District Office- Tenant Improvement

981 Ridder Park Drive, San Jose, CA 95131
MDG Project # 2203

MECHANICAL UPGRADES – BID #B-03-2022-23
ELECTRICAL UPGRADES – BID #B-04-2022-23
GENERAL CONSTRUCTION – BID #B-05-2022-23

October 21, 2022

DEMOLITION FLOOR PLAN
FIRST FLOOR

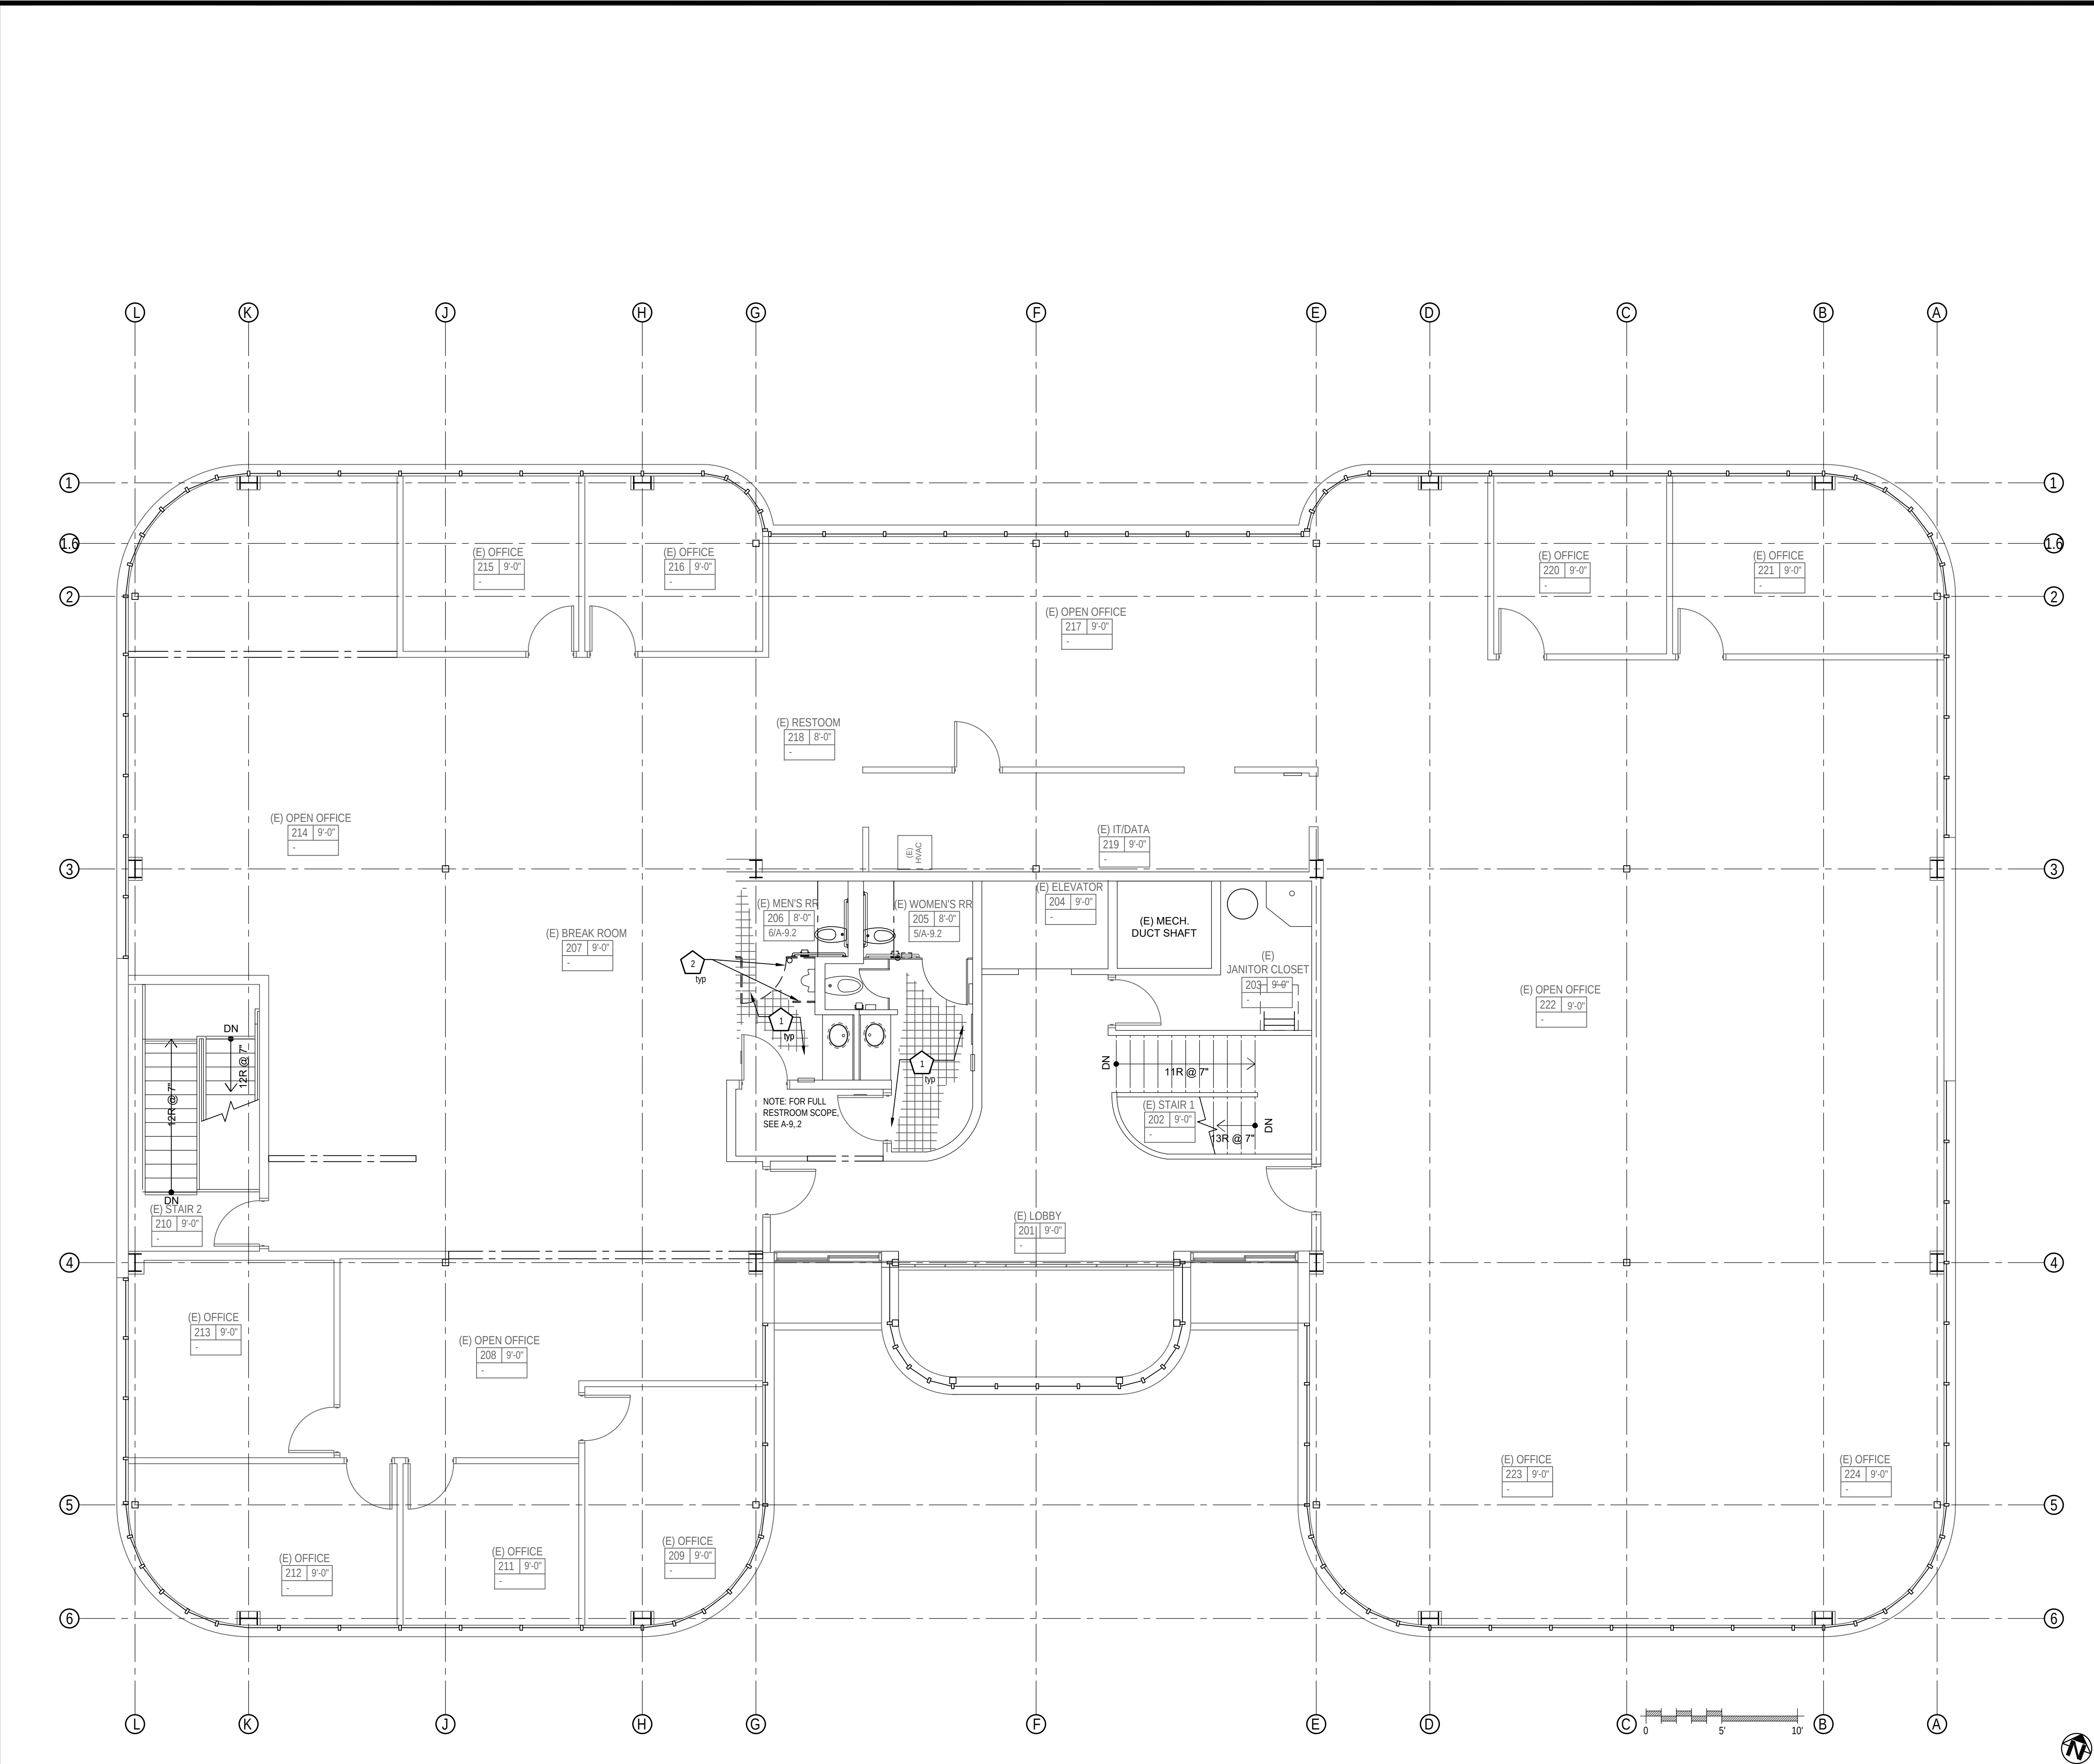
Item 2: Sheet A-2.1 Demolition Floor Plan- First Floor

- A. Please see added attached sheet for minor demolition scope

**DEMOLITION FLOOR PLAN
SECOND FLOOR**

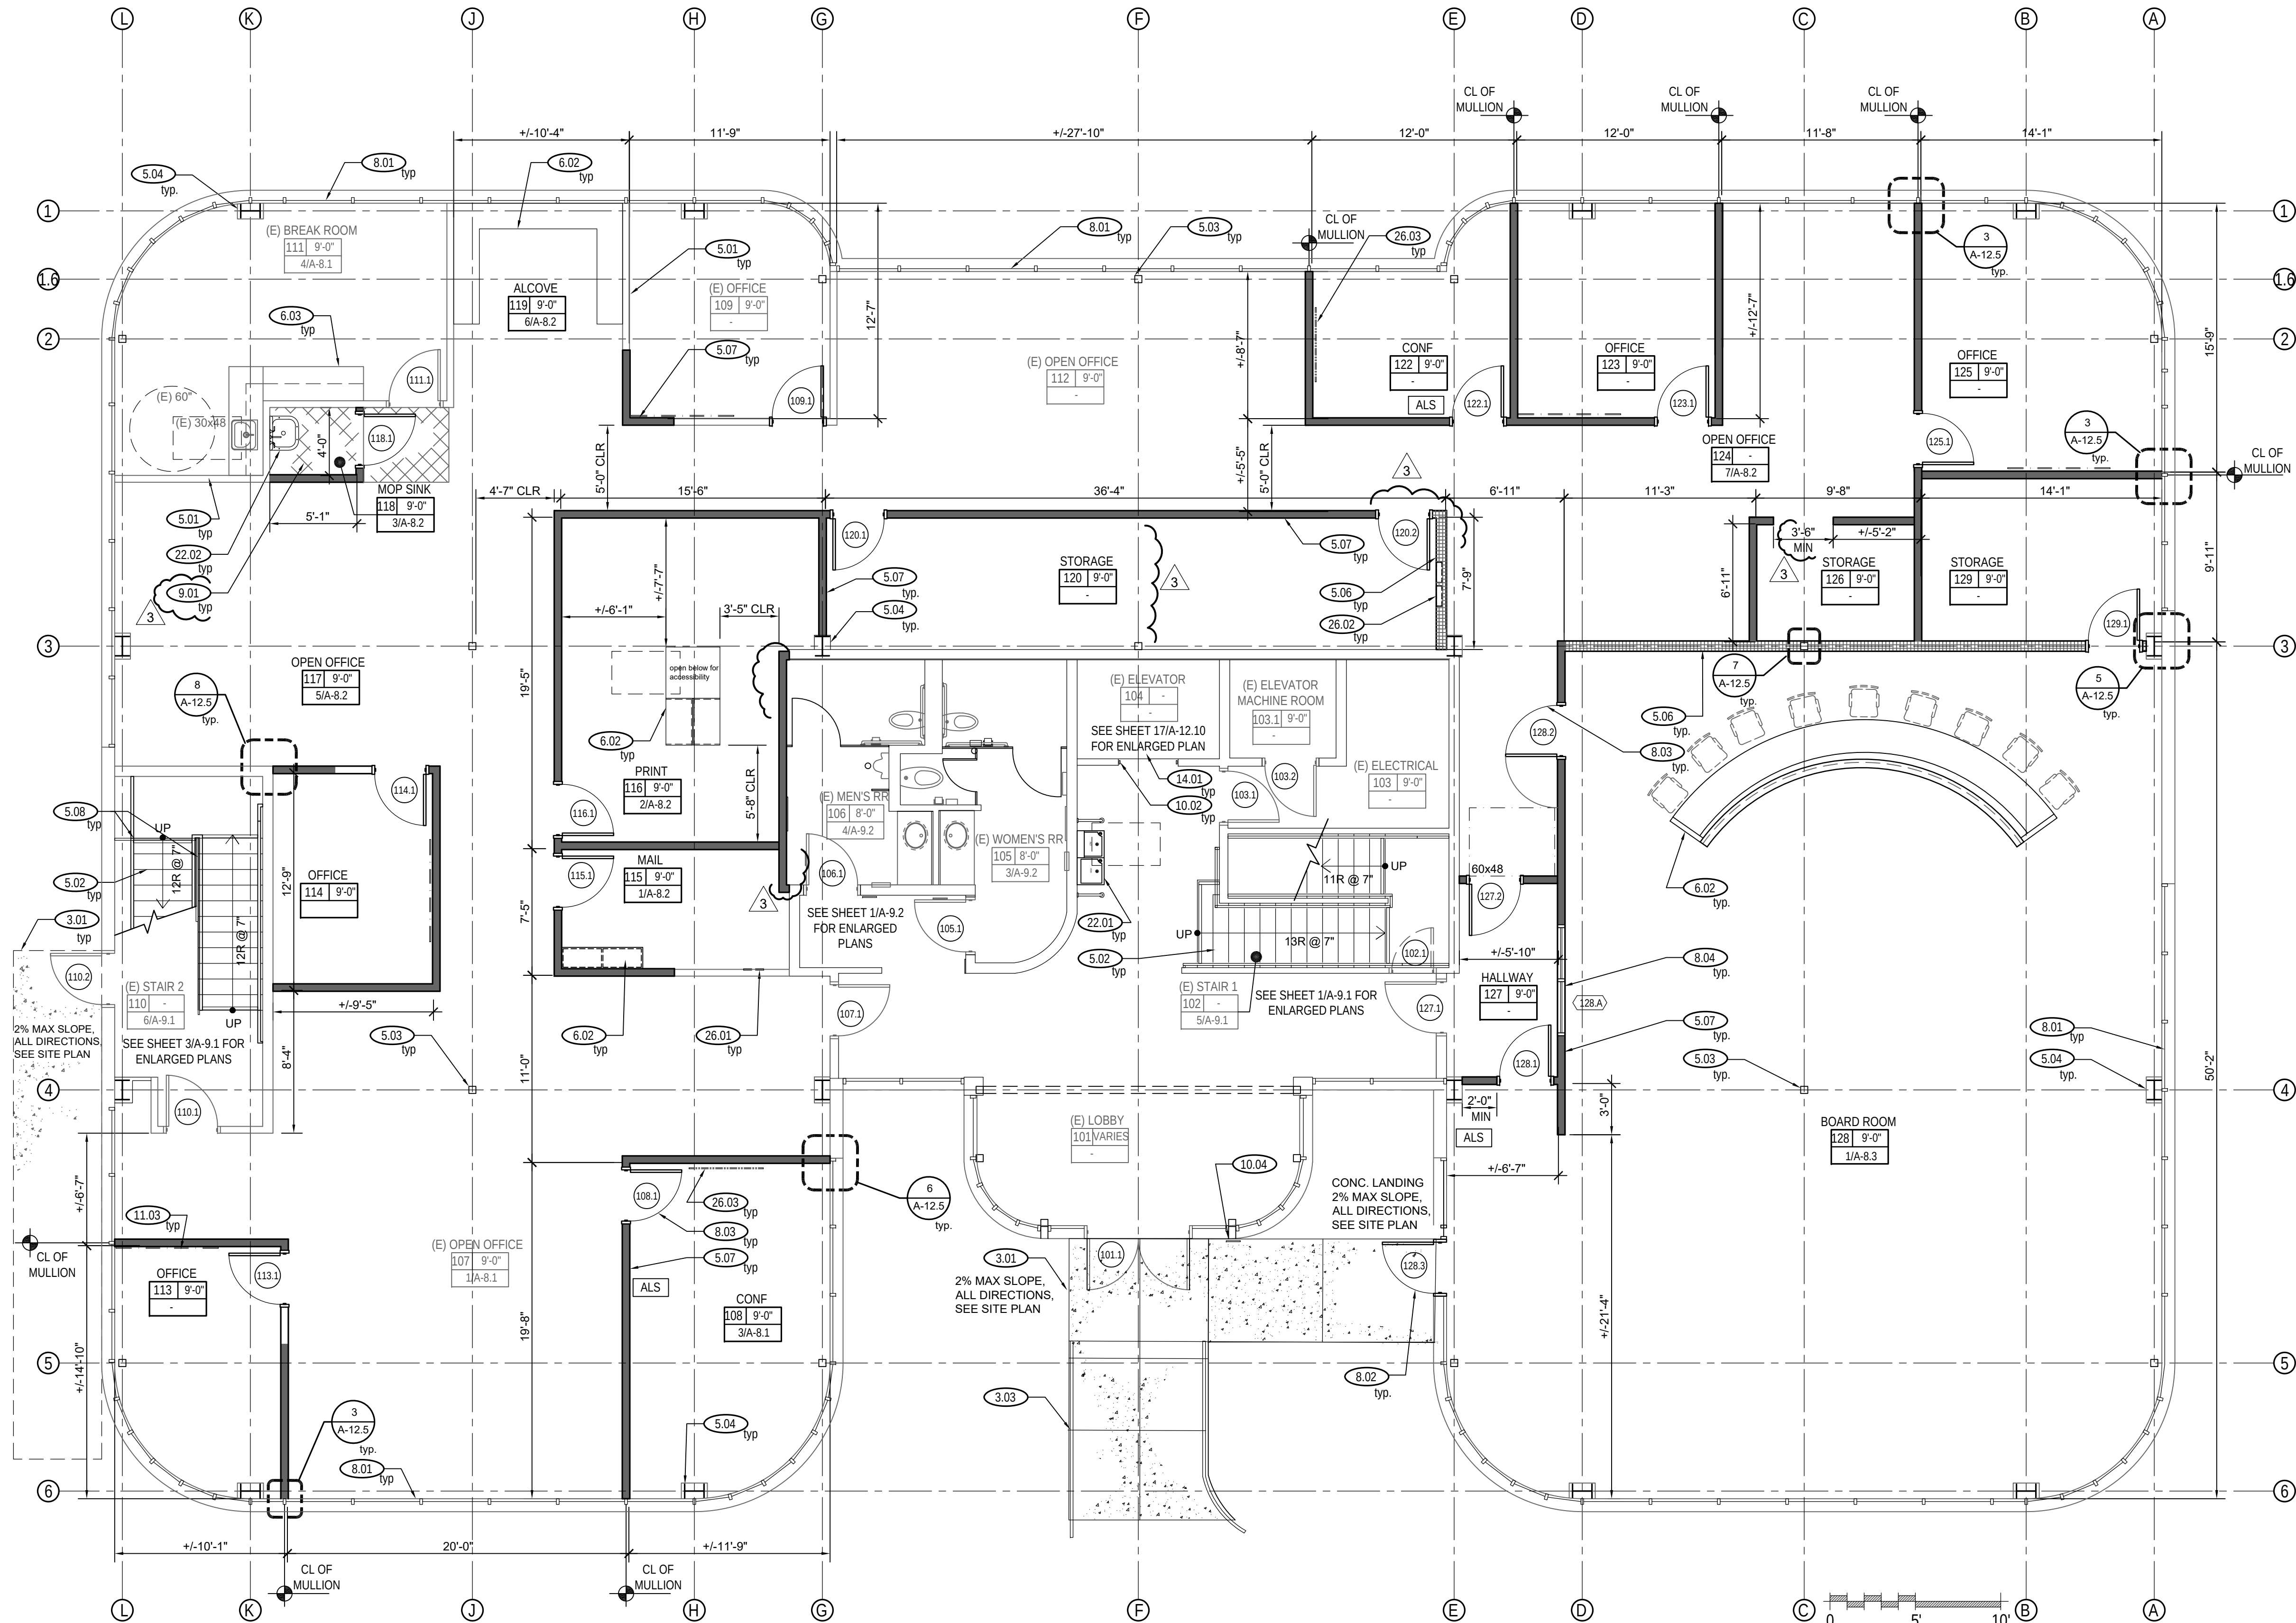
Item 3: Sheet A-2.2 Demolition Floor Plan- Second Floor

- A. Please see added attached sheet for minor demolition scope

**FLOOR PLAN
FIRST FLOOR**

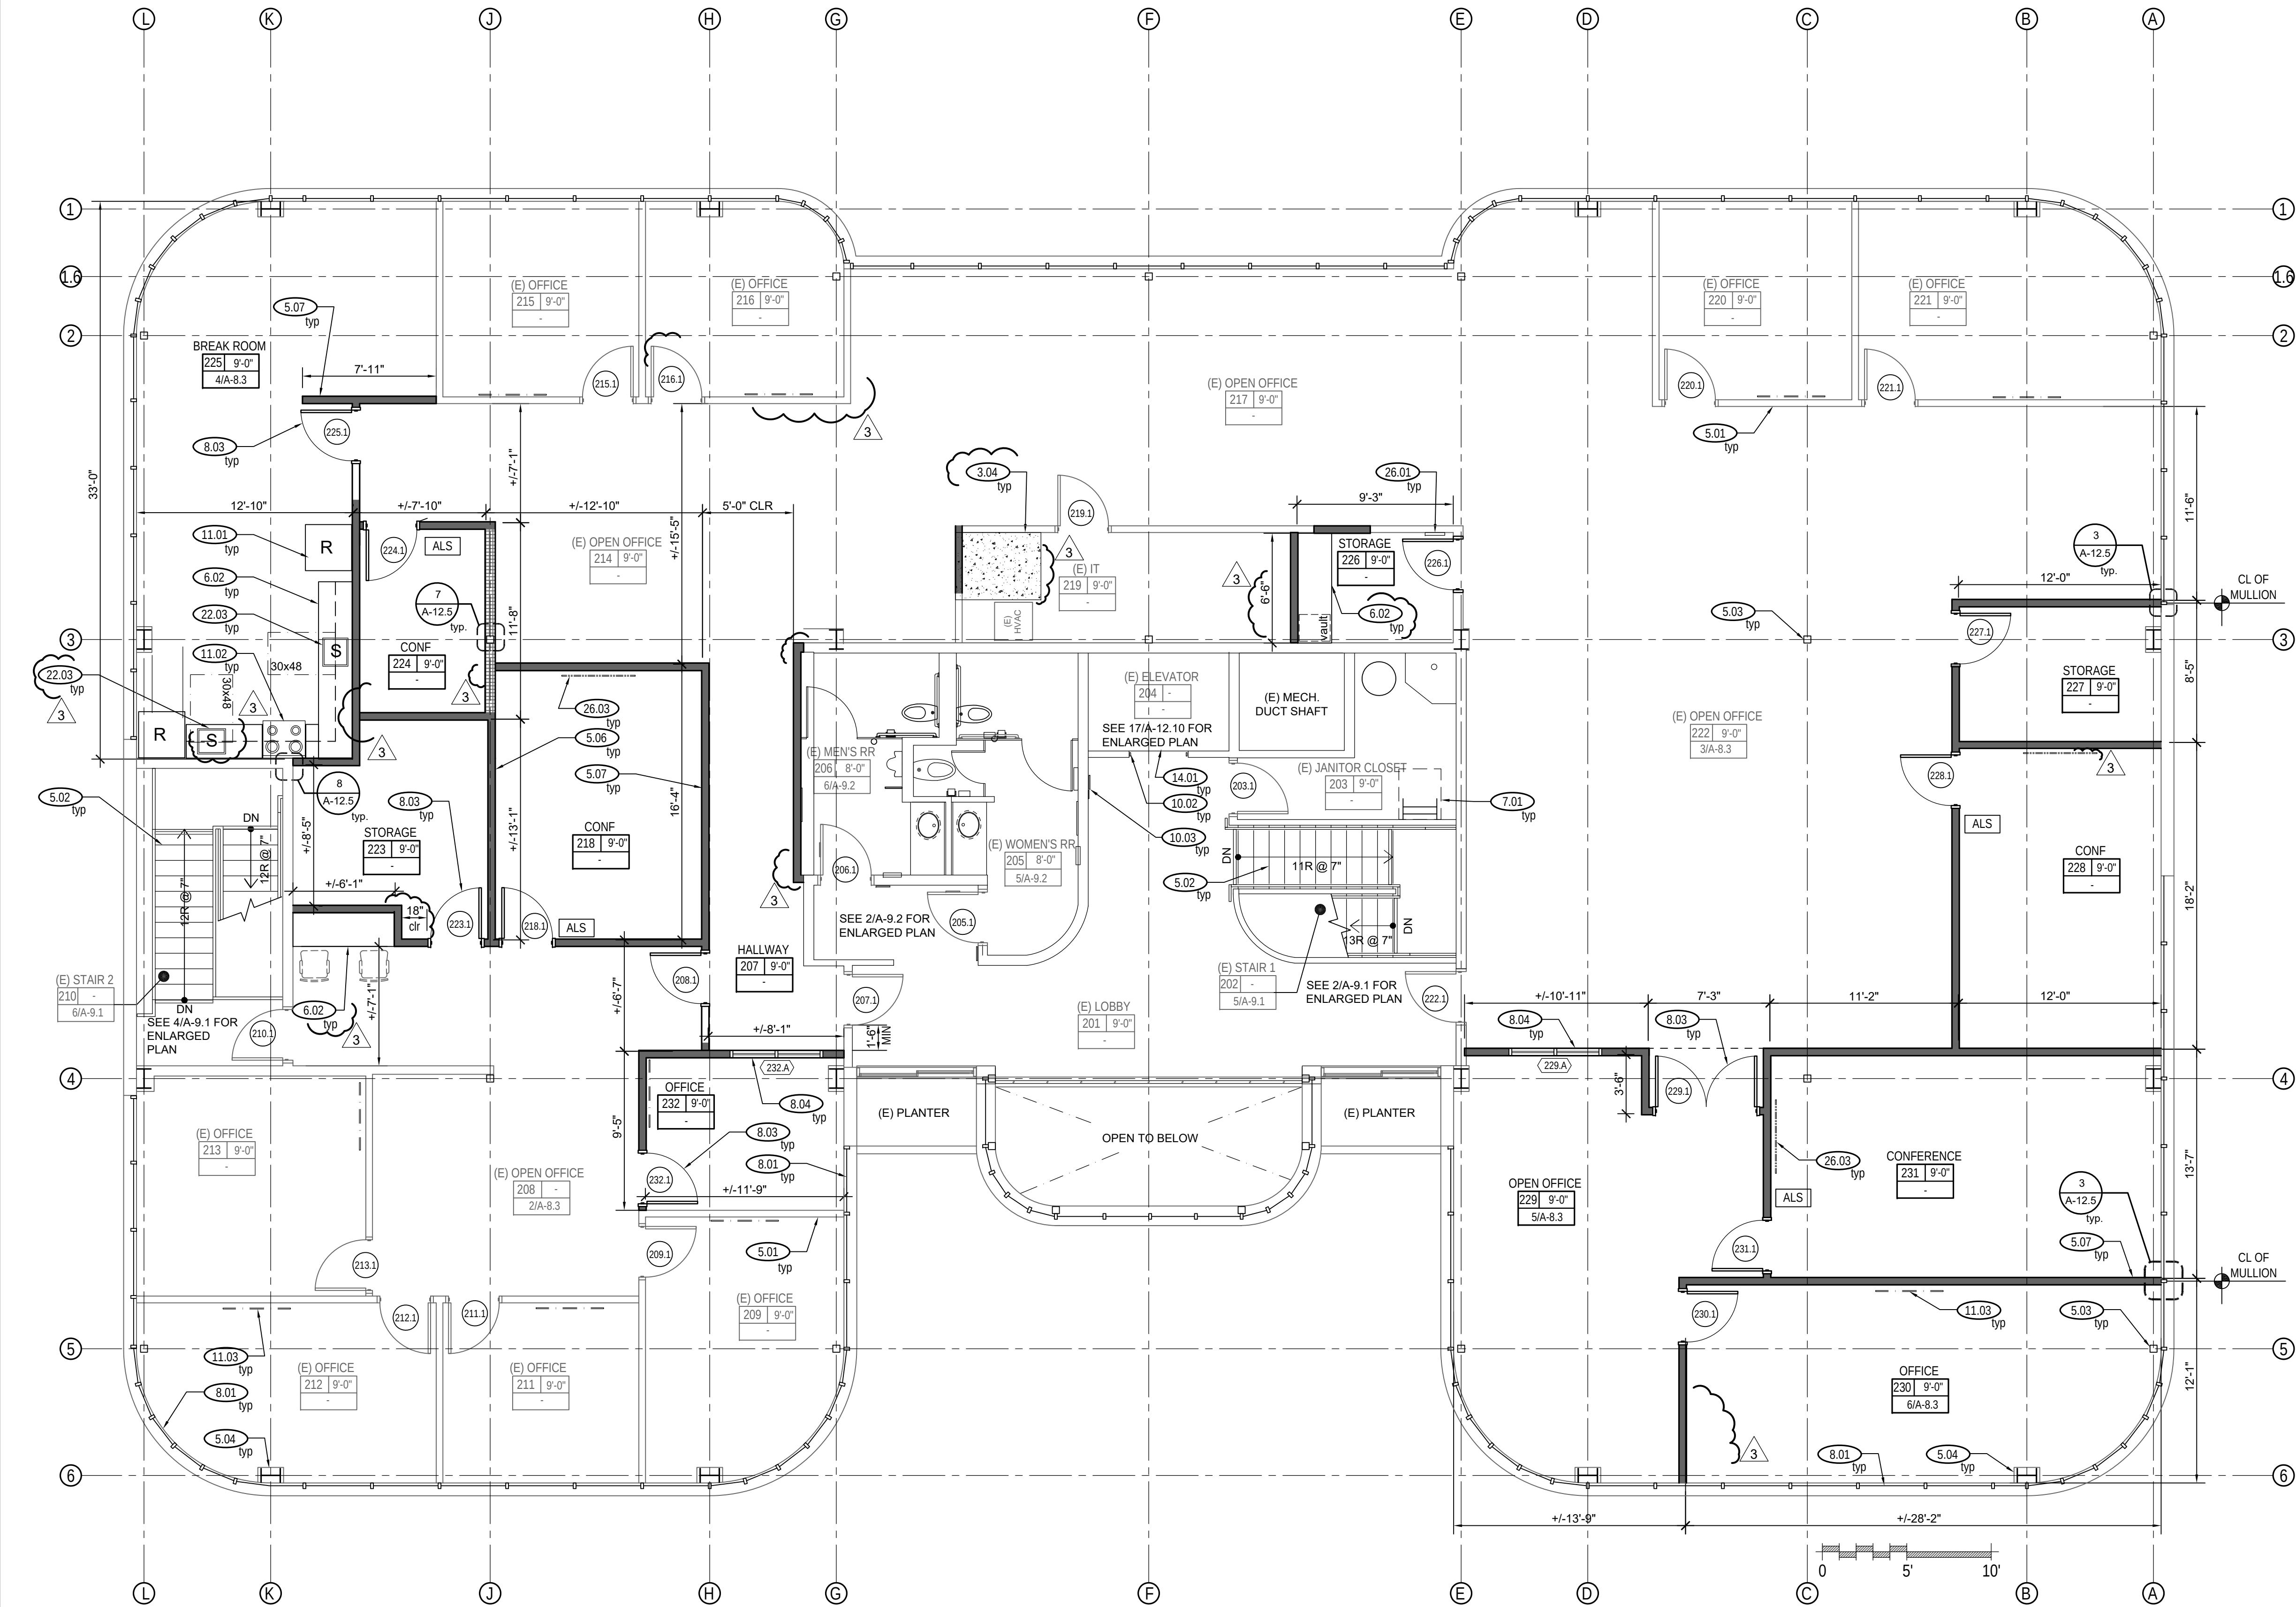
Item 4: Sheet 3.1 Floor Plan- First Floor

- A. See added wall hatch at Men's RR 106- West Wall.

- B. See added keynote at Mop Sink 118 which clarifies the flooring is to be VCT.
- C. See revised Storage 120 layout. Remove east wall between Storage 120 and Storage 121 and adjust door 120.2 location as show on plan.
- D. Change framed opening size from 3'-0" to 3'-6" at Storage 126.
- E. Provide new electrical panels keynote 26.02
